Drain: SPRINGMILL PONDS DRAIN **Drain #:** 240
Improvement/Arm: SPRINGMILL PONDS-SECTION 2
Operator: JOH **Date:** 7-12-04
Drain Classification: Urban/Rural **Year Installed:** 1991

GIS Drain Input Checklist

Re: **Springmill Ponds Drain - Sec 2 Arm**

SITE CONSTRUCTION PLANS FOR SPRINGMILL PONDS SECTION I & II

OFFSITE STORM SEWER PLAN &

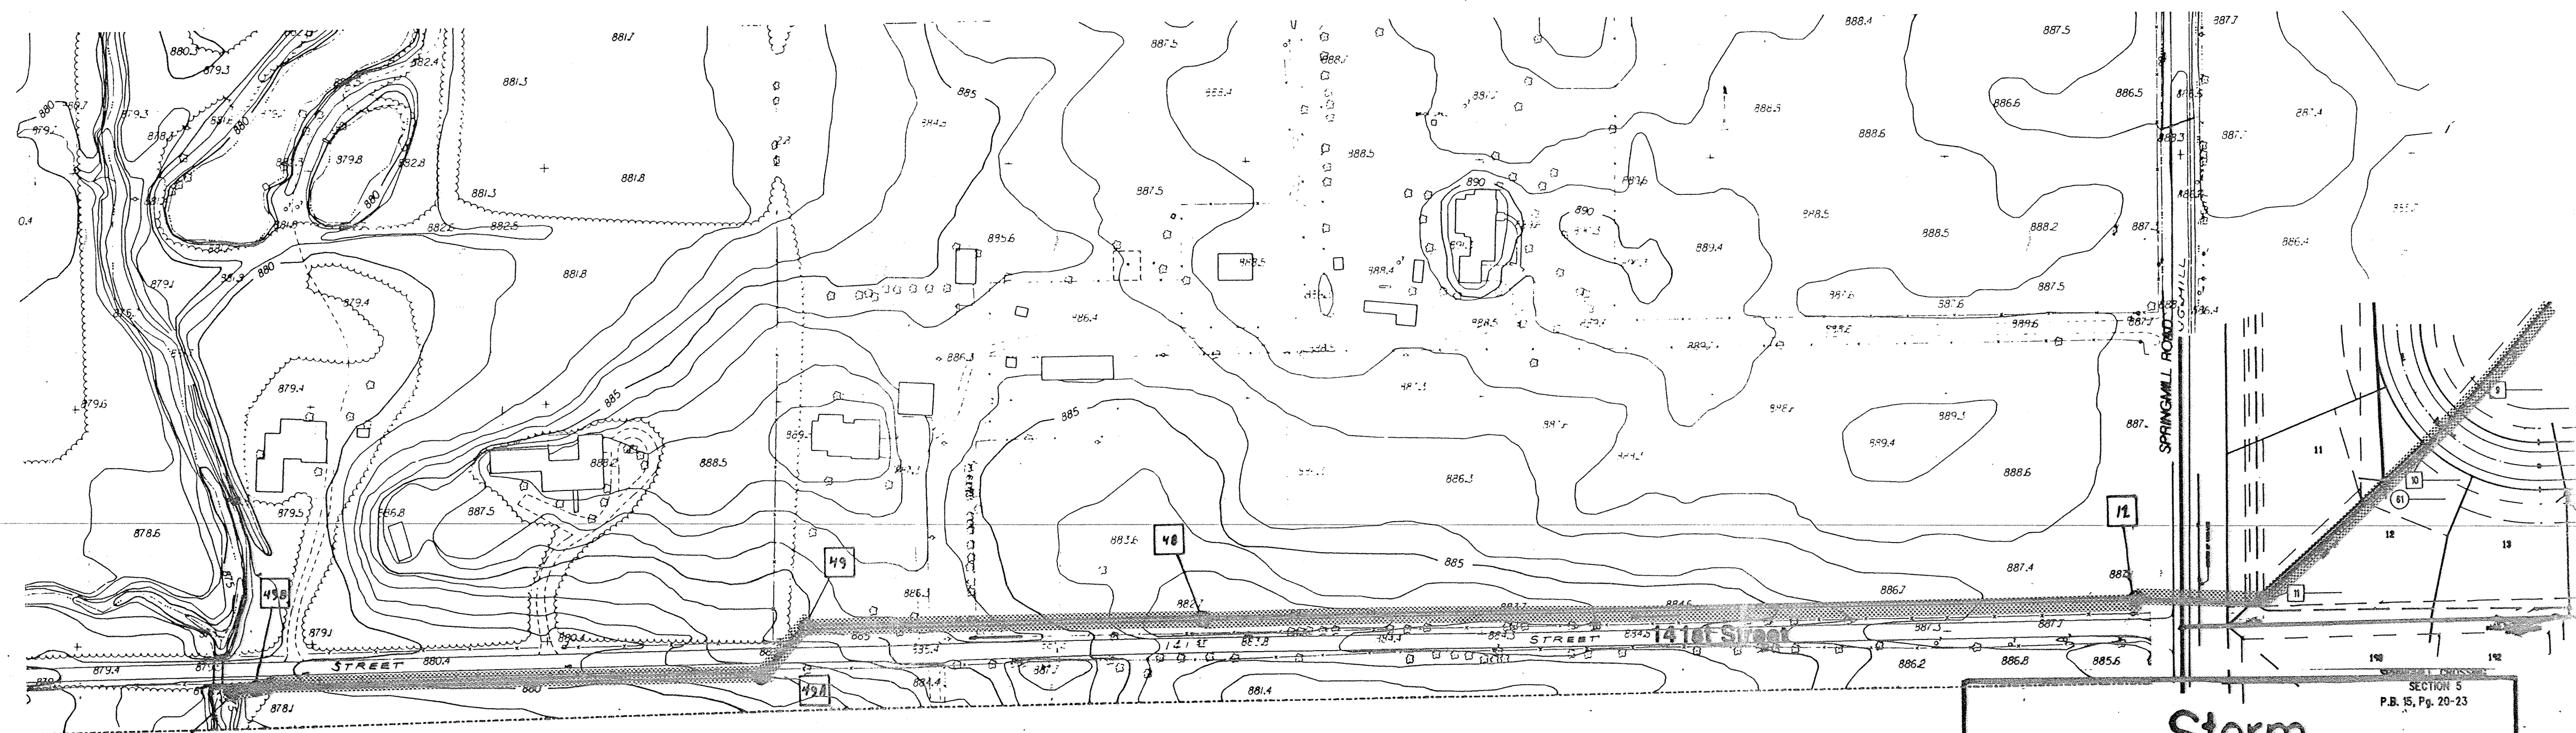
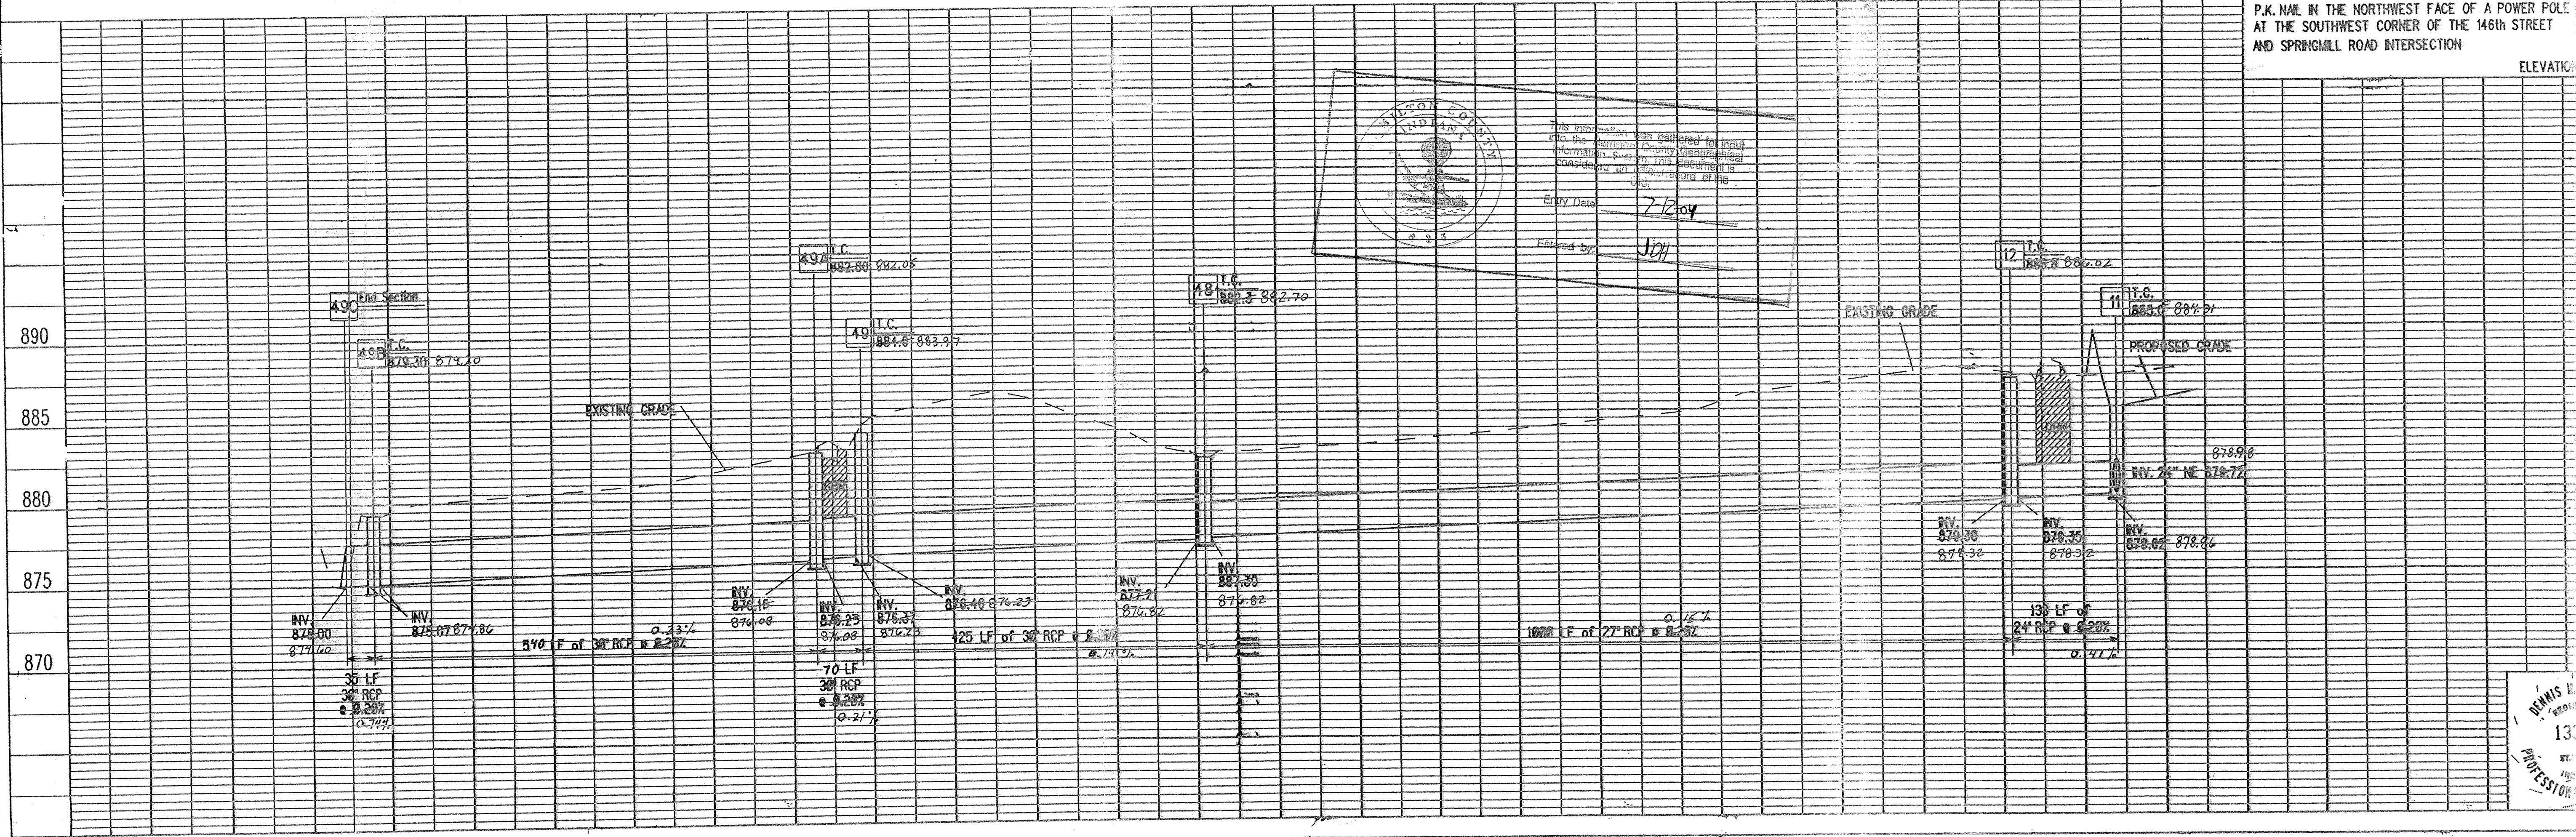
During construction, changes were made to the drain which will alter the plans submitted with my report for this drain dated October 11, 1990. The changes are as follows:
Structure 49B- Structure 49C was relocated for Buckhorn Subdivision. Structure 49A -Structure 49B now consists of 30" RCP at 567 feet. Structure 49B - 49C now consists of 16 feet of 36" RCP.

The length of the drain due to the changes described above is now 7567 feet.

Map Correction-Field Verification

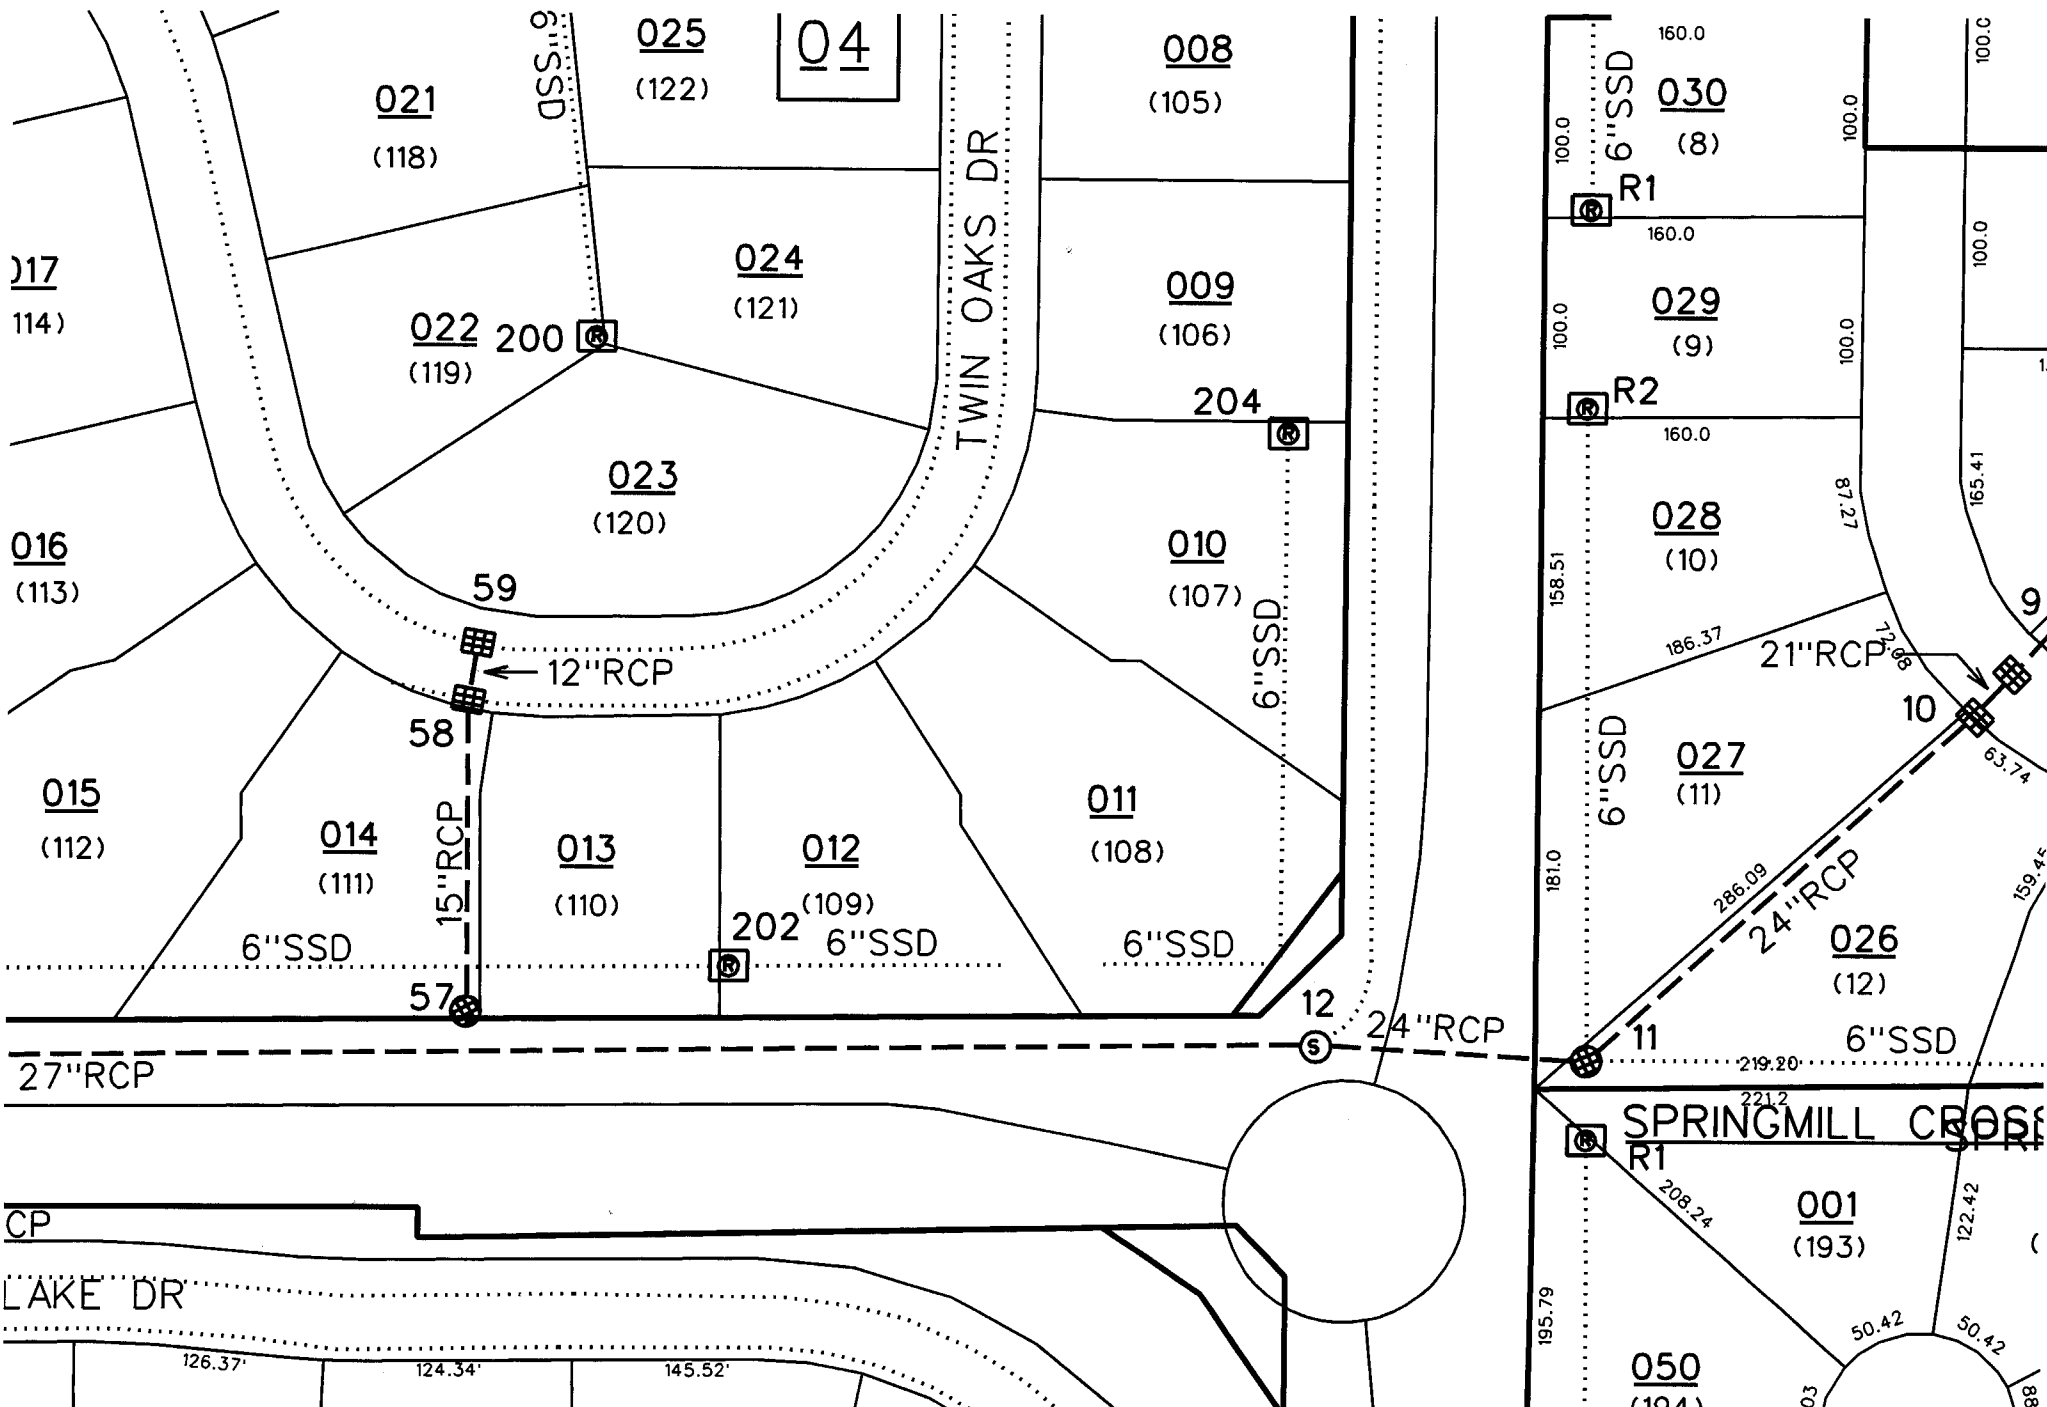
The road improvements made to Springmill Rd in 1997 changed structure 12 from an inlet to a manhole.
